Application for Licence Amendment

Licence Number	L9247/2020/1
Licence Holder	Beacon Mining Pty Ltd
ACN	603 853 916
File Number	DER2020/000120
Premises	Jaurdi Gold Project Mining tenements: M16/115, M16/529, M16/34, L16/120, M16/365 and part of M16/204 SHIRE OF COOLGARDIE WA As defined by the Premises maps in Schedule 1 attached to the Revised Licence
Date of Report	19/10/2023
Decision	Revised licence granted

Figure 1: Lost Dog in-pit TSF (Panel 2/4) monitoring bore

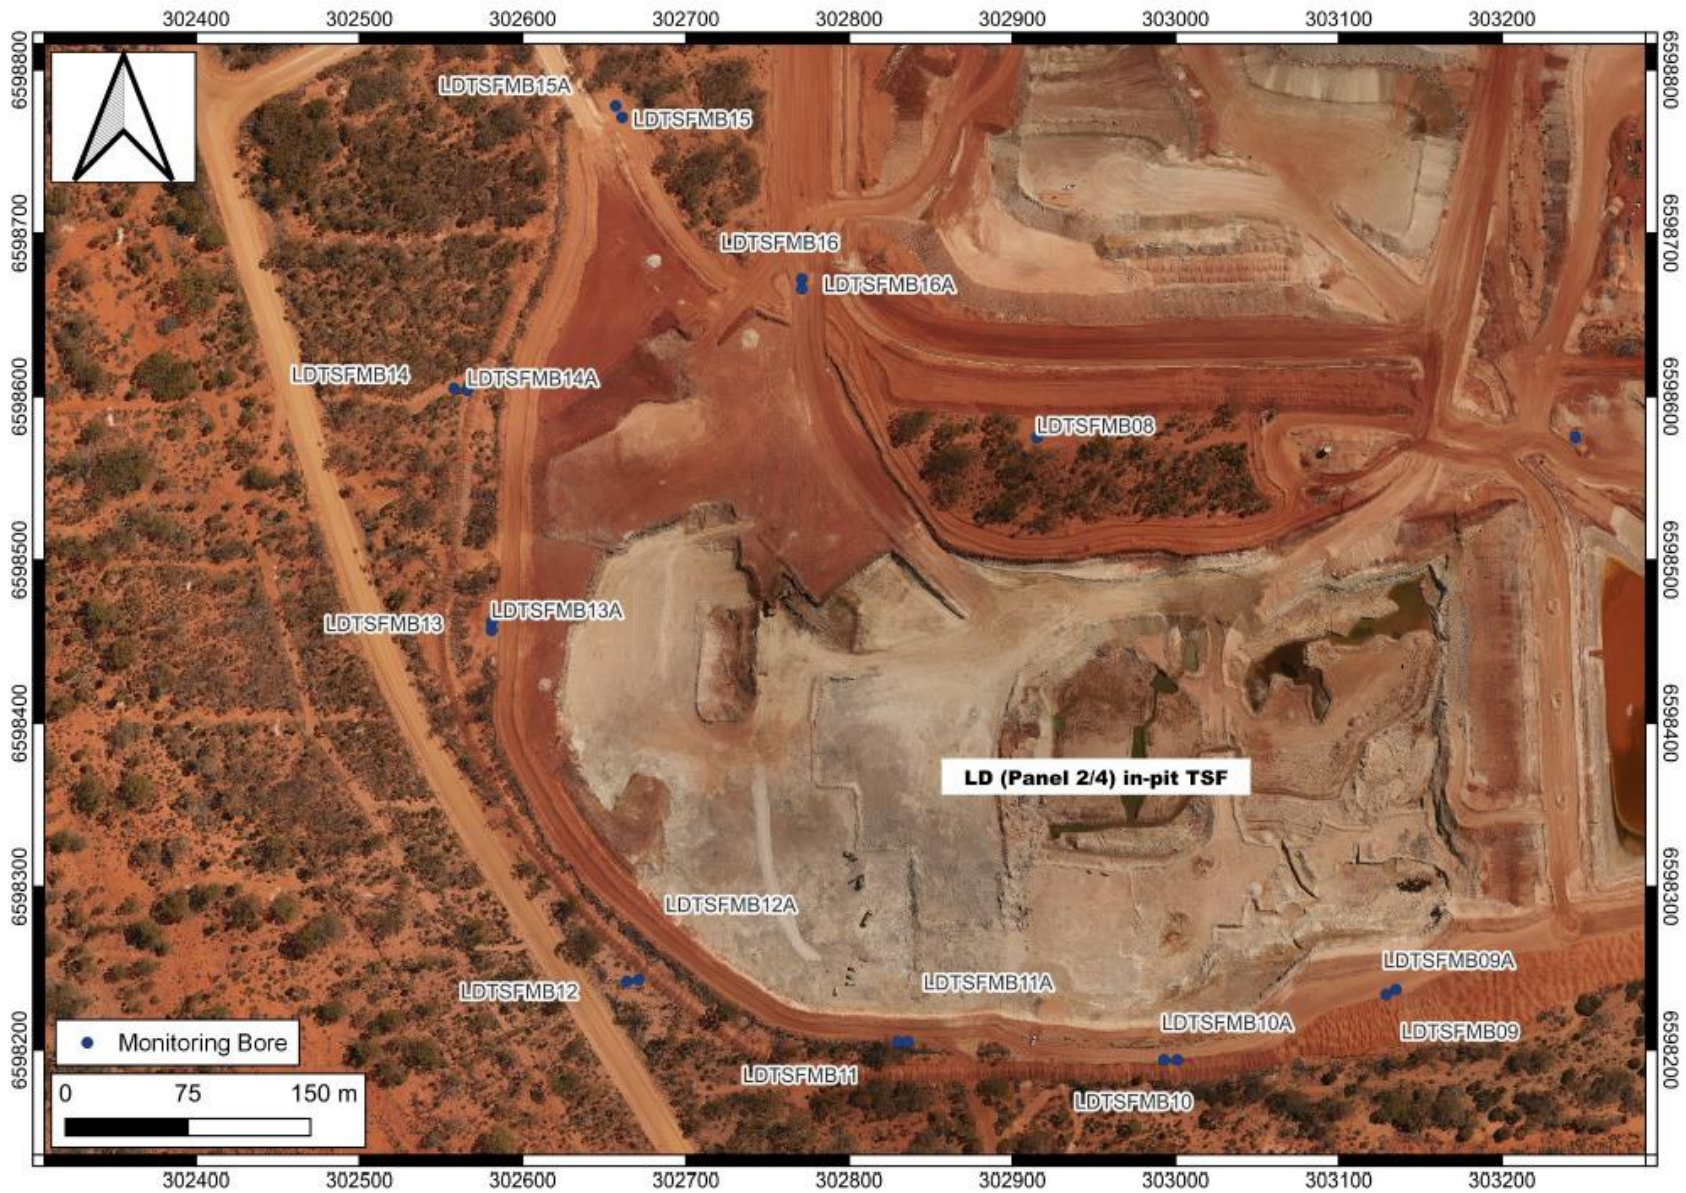
Technical review of the modelling noted that the model used is classified as having the lowest level of confidence for predicting changes to the groundwater flow regime that are caused by an imposed stress on an aquifer. This is because the model was largely calibrated using estimated values of aquifer parameters rather than from measurements of these parameters that were obtained by testing at the site.

The height of the groundwater mound was independently assessed using aquifer parameters that were provided in the seepage study report. The predicted elevation of the mound (about 45 metres) was similar to that produced by the Licence holder's model, that is, the predicted elevation of the groundwater mound caused by tailings disposal in the Lost Dog pit is plausible.

However, the independent assessment of mounding indicated that the elevation of the mound was very sensitive to changes to aquifer parameters like hydraulic conductivity and storage coefficient, and to the thickness of the aquifer. The predicted height of the groundwater mound was particularly sensitive to the initial saturated thickness of the aquifer, and mounding increases where the aquifer is at its thinnest. This could be a significant issue for the area near the Lost Dog pit, where a silcrete unit forms a local perched aquifer. If this unit is laterally

Technical review of the use of bores for groundwater recovery (a control proposed by the applicant) also noted that this can be problematic for the following reasons:

- Monitoring bores are constructed with a diameter smaller than required for optimal groundwater recovery, which restricts the volume of water which can be pumped to develop a significant cone of depression;
- Screening intervals are also not compatible. Monitoring bores are often 3-6 m long to enable monitoring to take place at a discrete depth within an aquifer, while recovery bores are often indiscrete at more than 10 m long; and
- The remaining monitoring bores cannot accurately measure standing water level trends for the region if a significant number of monitoring bores are repurposed.

Hydraulic conductivity directly influences pumping efficiency. At the Lost Dog In-Pit TSF, the sediments in the paleochannel are largely clayey and have a low hydraulic conductivity. Although sand and gravel beds occur within the paleochannel, these appear to be poorly interconnected. Consequently, it is likely that many pumping bores would need to be installed in these sediments to control groundwater mounding near the Lost Dog pit.

There is a large degree of uncertainty in the magnitude and timing of groundwater mounding that would take place as a result of tailings disposal in the Lost Dog pit. Additionally, it is not clear that the proposed groundwater recovery plan would be effective in controlling groundwater mounding. This is due to the generally low hydraulic conductivity of the paleochannel and bedrock aquifers in the area. However, on review of the monthly bore monitoring data for the other TSFs on site (Panther, Black Cat and Lost Dog in-pits) from the Annual Environmental Reports (AER) for the premises, it shows that Standing water levels did not breach the licence limit of 6 m below ground level (bgl). Spikes in WAD cyanide did occur during late 2020 and early 2021 but these are likely associated with the topping up of the pits, more acceptable levels were reached by late 2021. By nature of in-pit TSFs, seepage generally occurs below the vegetation root zone and despite the clayey soils promoting lateral seepage, to date, no vegetation degradation has been observed in relation to TSF seepage at the premises.

The Licence Holder has constructed 8 new monitoring/recovery bores and 8 shallow bores to be constructed around the LDTSP24 to monitor the groundwater levels over time. The deeper bores will have the ability to be converted to recovery bores if the need arises. The shallower bores have been conditioned within the licence and groundwater monitoring requirements expanded to include the new bores. An additional requirement to monitor for total cyanide, WAD cyanide and TDS within groundwater bores have been added to the licence as these are important parameters to be measured when monitoring for seepage impacts.

A trigger value of 6 mbgl have also been conditioned for standing water levels for these bores

along with a requirement to undertake pumping from the recovery bores if this trigger value is exceeded.
